Product Change Notification / RMES-180AWC144

CCB 2929.003 Final Notice: Qualification of NSEB as a new assembly site for MCP33141 and MCP33151 device families available in 10L MSOP (3x3mm) package

CCB 2929.003
Pre and Post Change Summary
PCN #: RMES-18OAWC144

ANAP

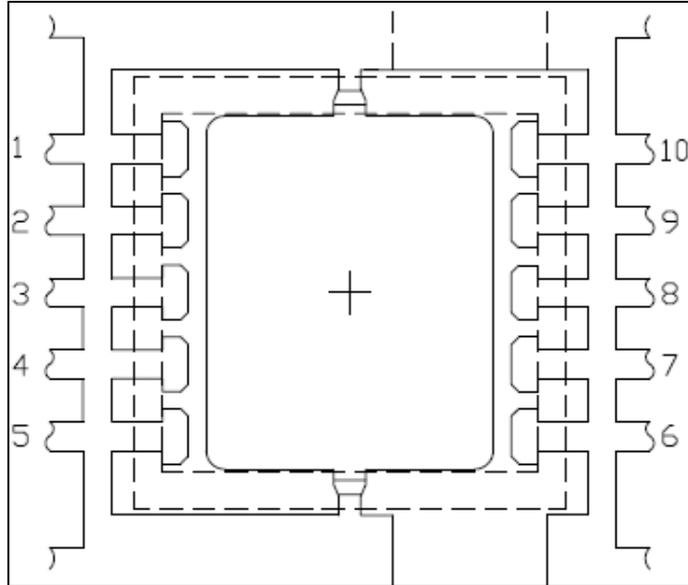
Lead frame Comparison

Paddle size

78 x 97 mils

NSEB

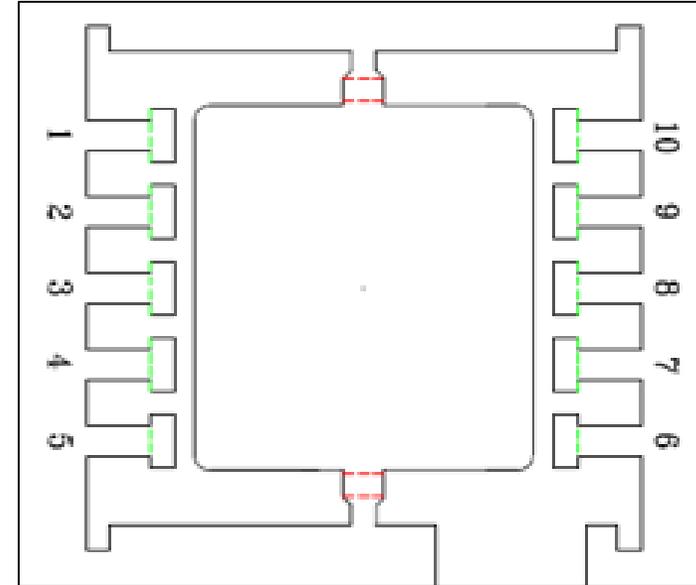
Paddle size

82 x 94 mils
